The difference between (original) and NEW for JBL GO VM Appearance:
add additional Li-Po Battery , change power charge IC

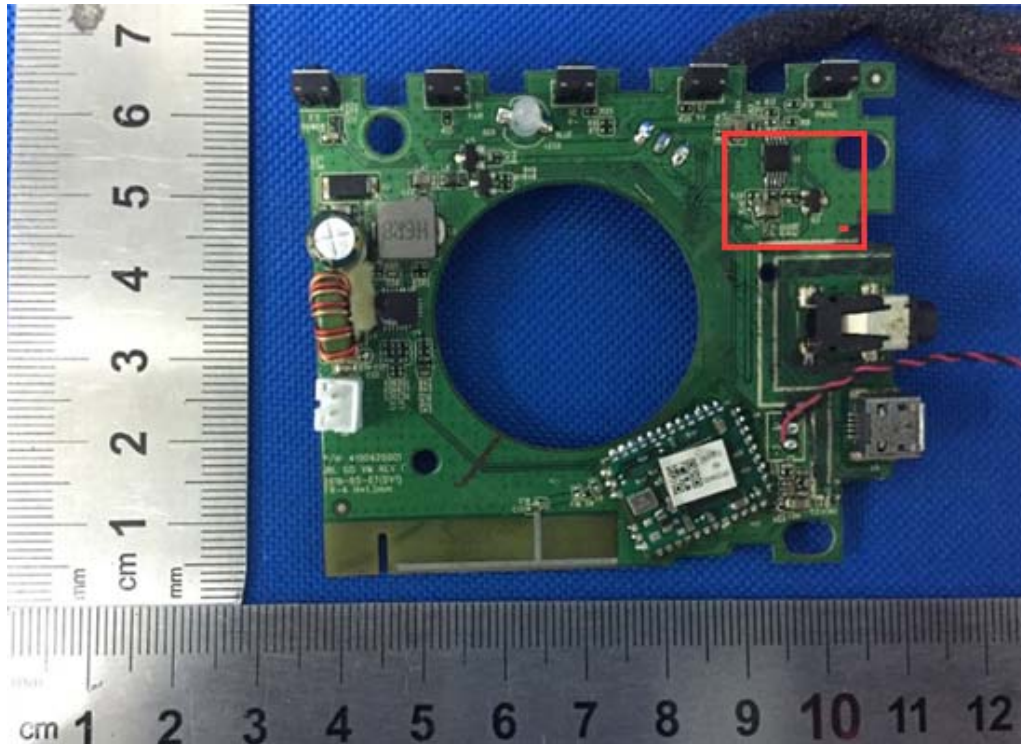
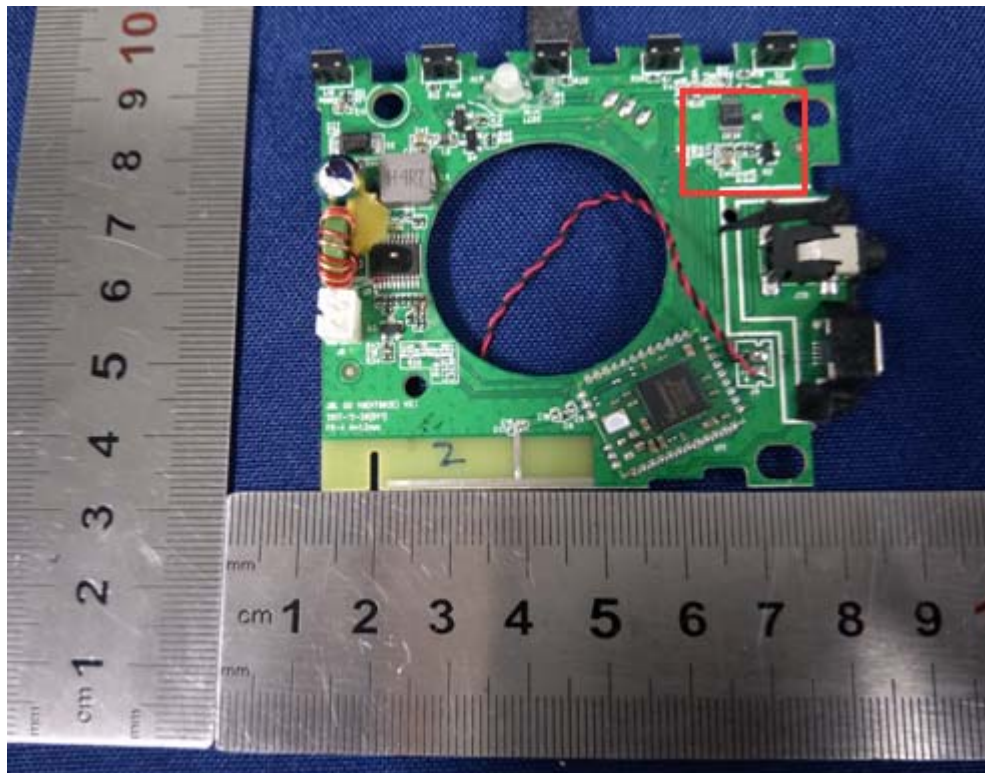
Original power Charge IC

NEW power Charge IC

Original

Built-in battery mode: MLP284154

New

Built-in battery mode: L0728-LF
